Temporary Traffic Arrangement for Temporary Run-In Out for Construction Works at Kc Sheung Road near Nam Hing West Road

Applicant's letter ref. no. NU/OTH/011468 dated 16 Aug 2024

Agreed via fax (3747 3221) on 28 Aug 2024 with the following Approval Conditions :

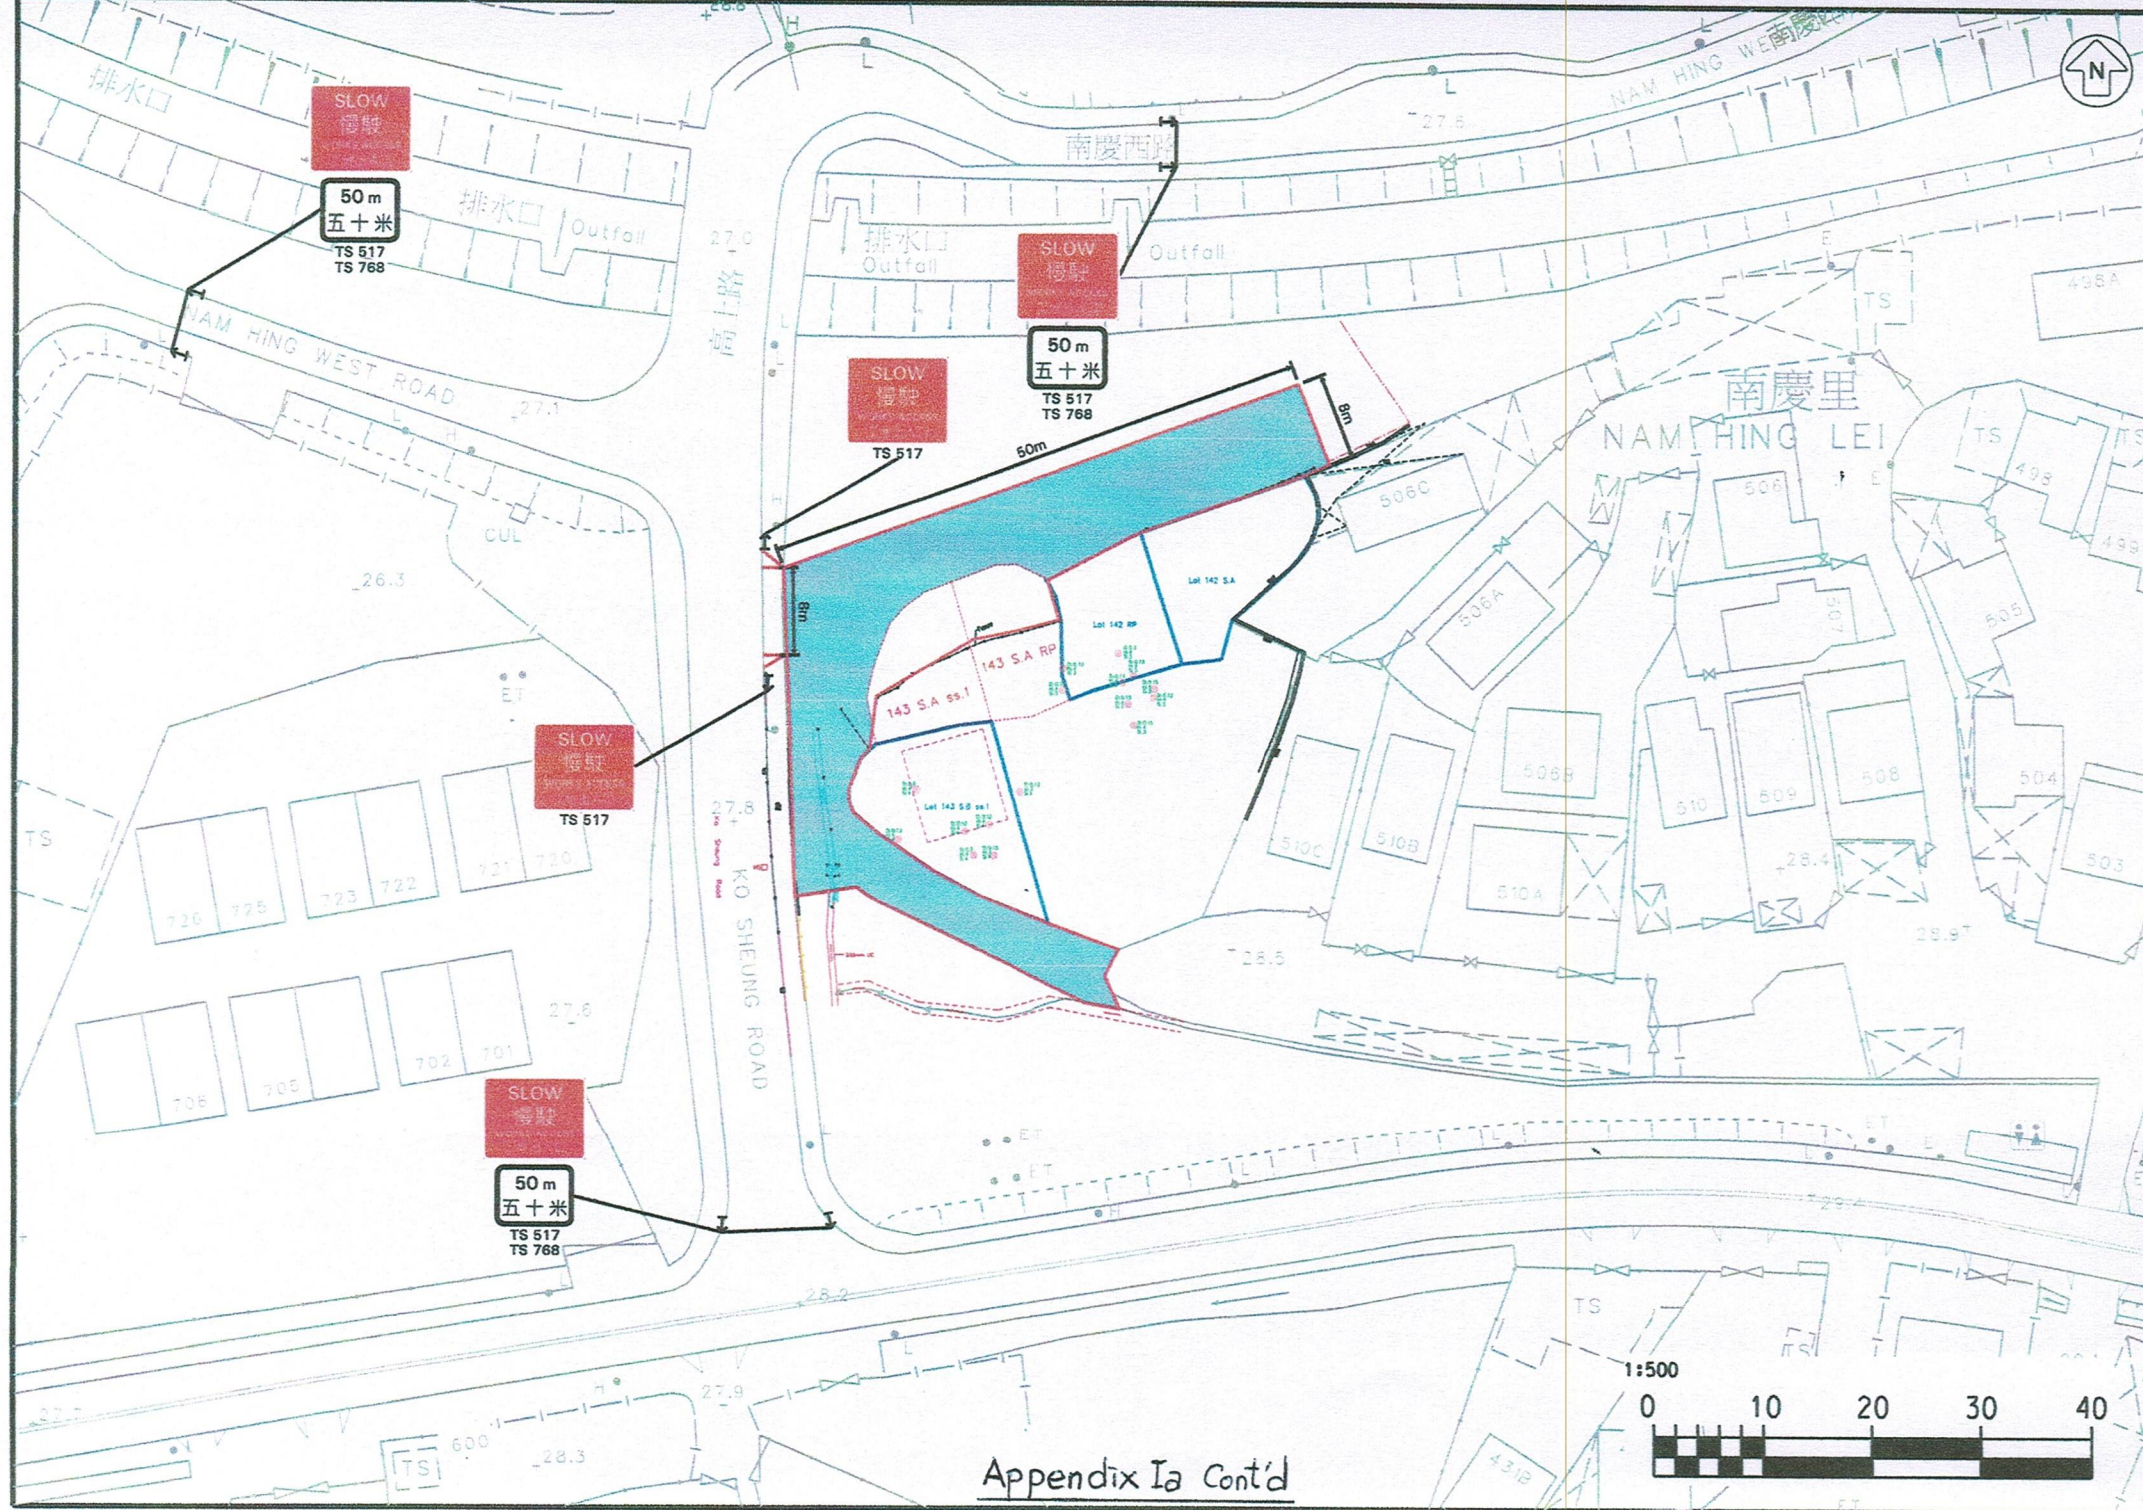
- 1) Please liaise with locals and affected stakeholders before commencement of the proposed works.
- 2) As the works area as shown is outside the purview of TD, please verify the road/land status, seek prior comments and obtain consents from relevant managerial departments/affected parties/stakeholders.

- 3) Please provide the purpose of works area in detail.
- 4) As the proposed vehicular access/run-in/out is temporarily implemented on a footpath, please submit relevant drawing in detail to lay out the TTA for implementation of such vehicular access and pedestrian traffic control on footpath during implementation.

- 5) Please also liaise with district maintenance division of Highways Department beforehand for any removal of existing street furniture such as type II railings on the back of footpath. Such railings shall be immediately reinstated upon completion of works.

- 6) The plastic barriers as shown shall be provided with flashing lanterns for 24-hour TTA/works and shall be specified on the legend.
- 7) Water-filled barriers rather than plastic barriers shall be provided along the back of footpath when there is an adjoining slope or retaining wall underneath, please verify on site accordingly.

- 8) The both sides of vehicular access/run-in/out shall be provided with amber revolving lanterns.
- 9) Banksman shall be deployed at the vehicular access/run-in/out for manual traffic control when necessary.

- 10) Swept path analysis of construction/works vehicle for ingress/egress at the vehicular access/run-in/out shall be demonstrated.
- 11) Adequate and unobstructed sightlines shall be maintained at/near the vehicular access/run in/out.

- 12) Please seek prior comments and obtain consent from Traffic Police.
- 13) Please ensure no other concurrent TTA scheme nearby unless prior approvals/consents granted by TD and Traffic Police.

- 14) Please revise the anticipated programme of works for six months maximum and submit application for re endorsement every six months.
